# UNITED STATES PATENT AND TRADEMARK OFFICE

APPLICATION NO.	FILING DATE	FIRST NAMED INVENTOR	ATTORNEY DOCKET NO.	CONFIRMATION NO.
10/532,277	04/21/2005	Andrea Drollinger	14150	8515
<div>Orum &amp; Roth 53 West Jackson Blvd Chicago, IL 60604-3606</div>				
<div>7590      01/29/2008</div>			<div>EXAMINER KAVANAUGH, JOHN T</div>	
			<div>ART UNIT 3728</div>	<div>PAPER NUMBER</div>
			<div>MAIL DATE 01/29/2008</div>	<div>DELIVERY MODE PAPER</div>

<b>Office Action Summary</b>	Application No. 10/532,277	Applicant(s) DROLLINGER ET AL.	
	Examiner /Ted Kavanaugh/	Art Unit 3728

## **DETAILED ACTION**

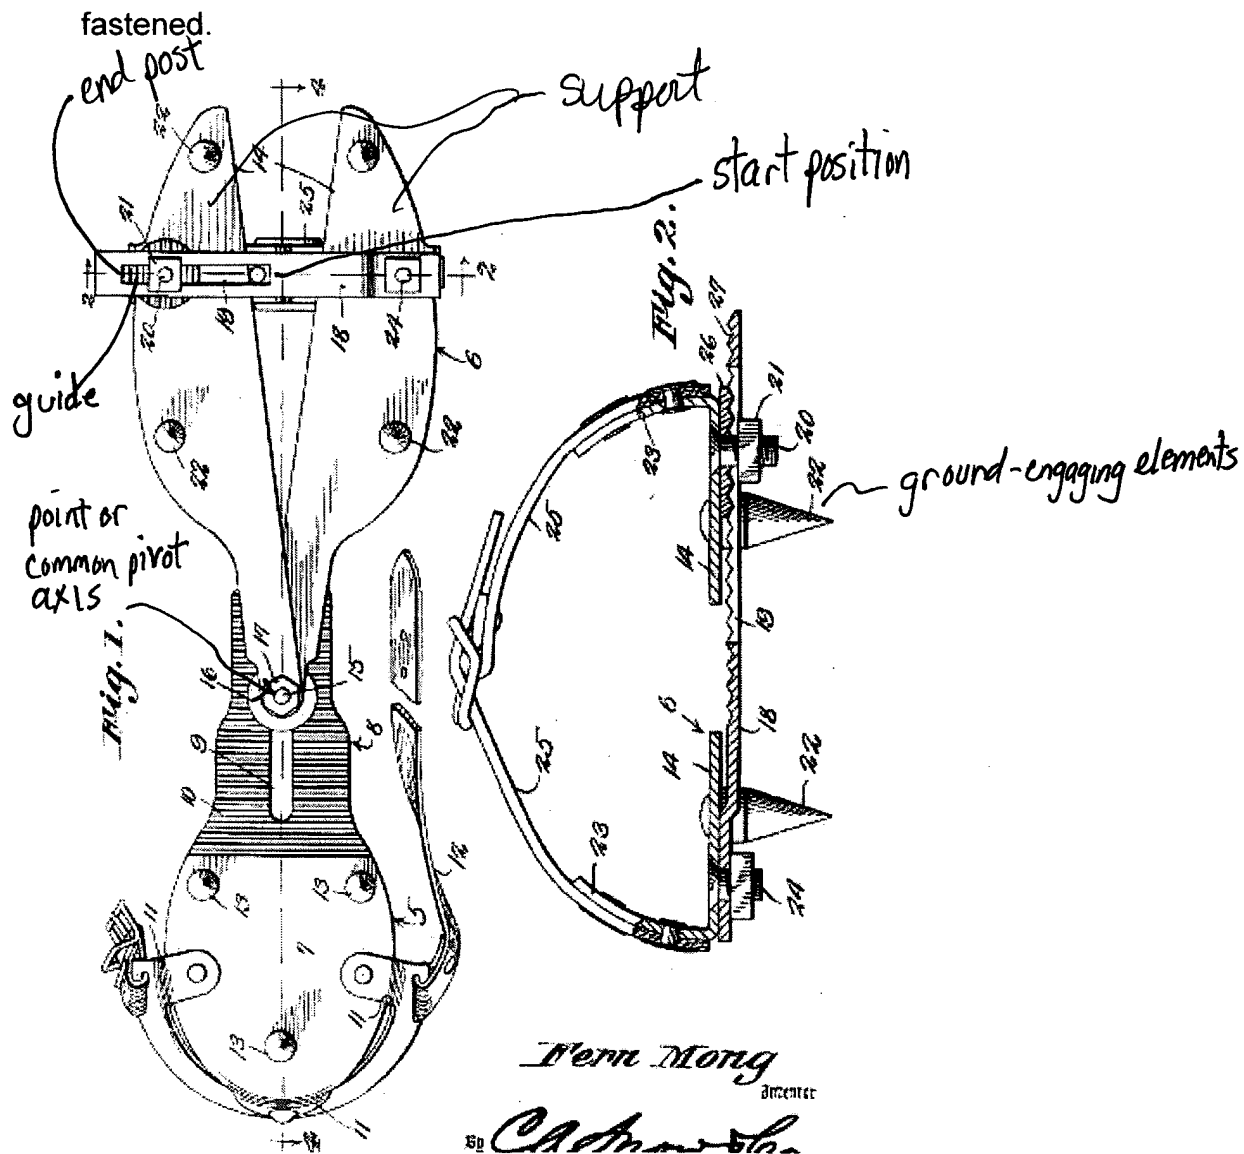
5. Claims 1-5,11,25-27,48-56 are rejected under 35 U.S.C. 102(b) as being anticipated by US 2002706 (Mong).

Mong teaches an ice creeper (sole with downwardly projecting ground elements) which is detachably mounted on a shoe, wherein the ice creeper has two support plates with ground-engaging elements which are guided and held to move forward and backward along an arc; see the marked-up figure below. The shoe can inherently be used for sports. The center of curvature is about the bolt 15 which is between the heel and the forefoot of the shoe. The mounting elements could be the bolt and nut (15,17) which are capable of being movable at all times inasmuch as anyone could thread or thread them together. Also the mounting means could be the toe section members

(14,14) which are also movable at all times when the bolts and nuts are not tightly
